QUESTION 1 Page 3-1;

What correlation exist between the spectra in Figure 3-1 and Figure 3-2?

FIGURE Q2.1 17x17 OPTIMIZED FUEL ASSEMBLY LATERAL STIFFNESS TEST SETUP AND STRAIN GAGE LOCATIONS

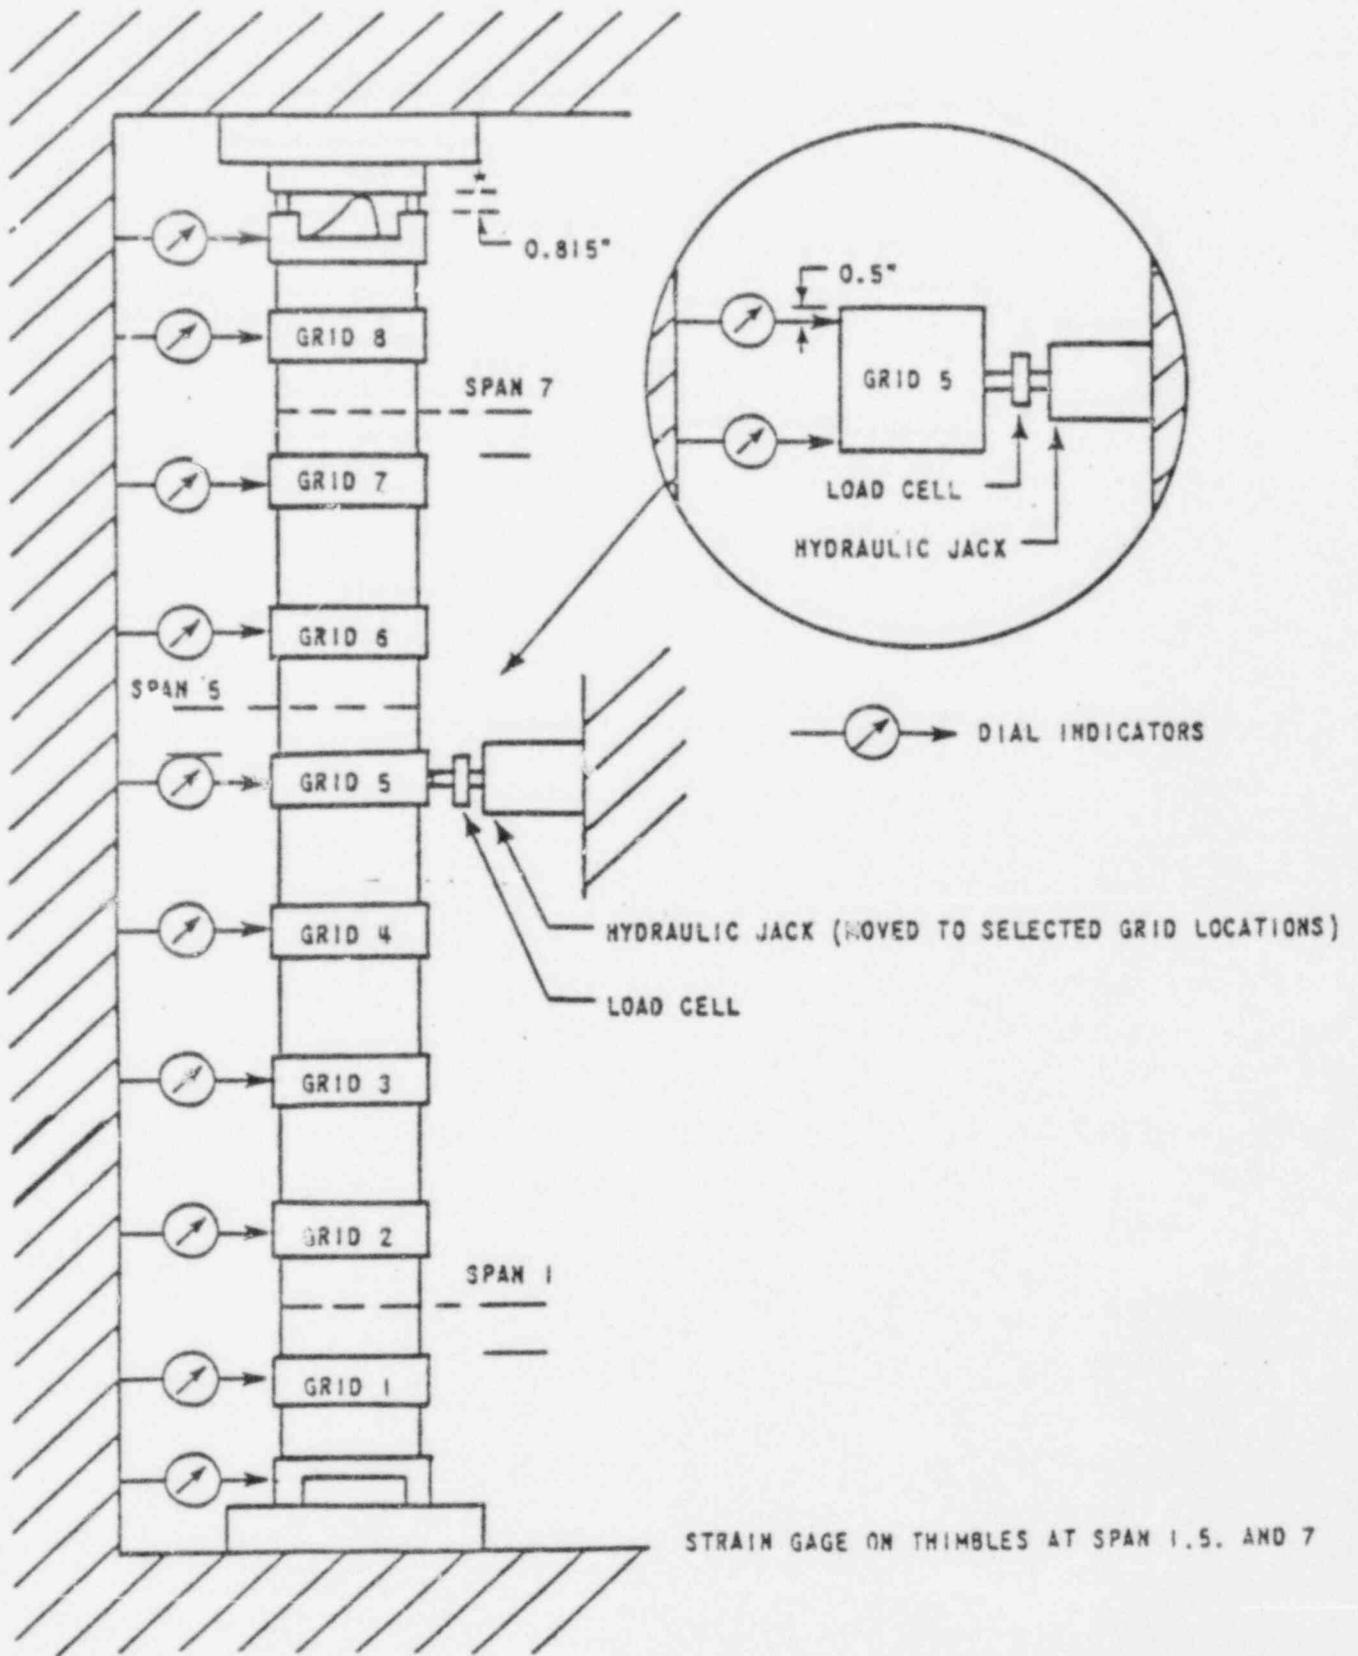
QUESTION 2      Page 3-6 and; Q1 question 12

Comparisons between analytical models and experimental results are important. Although the model has not changed, the experimental fit of the model has. Supply quantitative comparable experimental and analytical stress-strain results and a basis for comparison of these results.

The strain data was obtained at selected thimble locations during the optimized fuel assembly lateral loading test. The test set-up as well as the gage locations is schematically shown in Fig.Q2.1. The thimble stresses derived from the strain reading are shown in Figure Q2.2.

FIGURE Q13.1 17x17 OPTIMIZED FUEL ASSEMBLY LATERAL IMPACT TEST SETUP

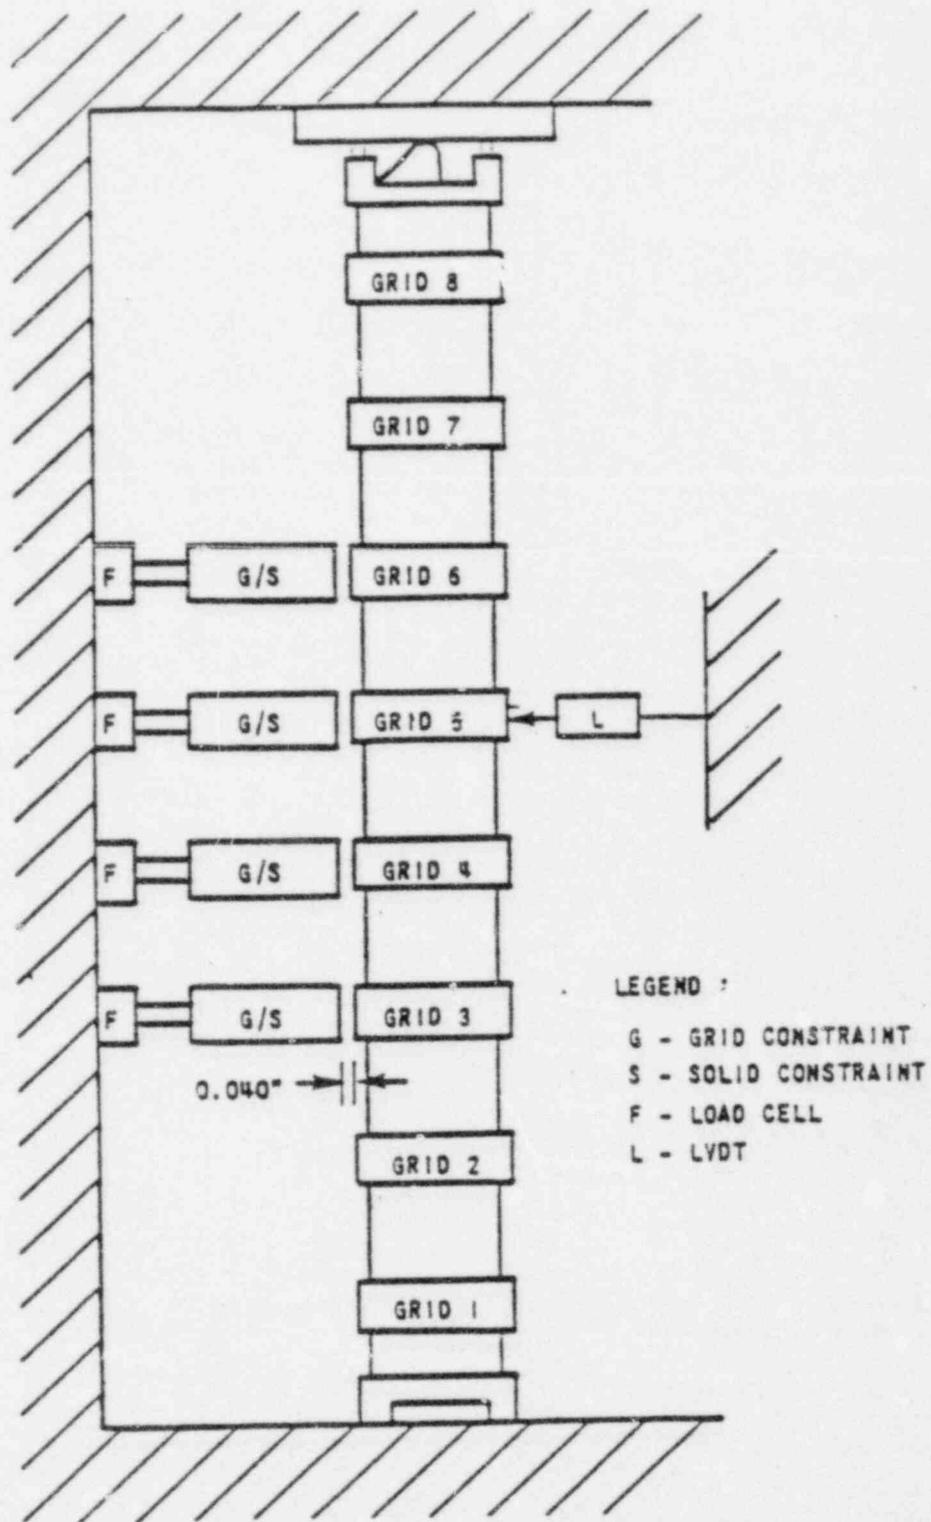
The methods used for determining  $K_s$ ,  $C_s$ ,  $K_g$ ,  $C_g$ , and the critical load ( $P_{crit}$ ) have been discussed and information supplied supporting the values derived for the inconel spacer grids. The incorporation of Zircaloy grids in the fuel assembly design will effect the response of the fuel system and certain spacer grid allowable loads. To completely review this situation, the following information is requested:

- a. test data supporting the in-grid stiffness and damping values chosen,
- b. test data supporting the through-grid stiffness and damping values chosen, and
- c. test data supporting the value of  $P_{crit}$  chosen.

The local grid flexibility (or in-grid stiffness damping values)  $K_s$  and  $C_s$  are derived from the fuel assembly lateral impact tests. The fuel assembly lateral impact test arrangement is shown in Fig. Q13.1. The impact duration obtained from these tests was approximately [ ]<sup>+</sup> sec. A correlation analysis was performed using the lumped mass-spring analytical model to verify the model by comparing the grid impact forces. These results are given in Table Q13.1.
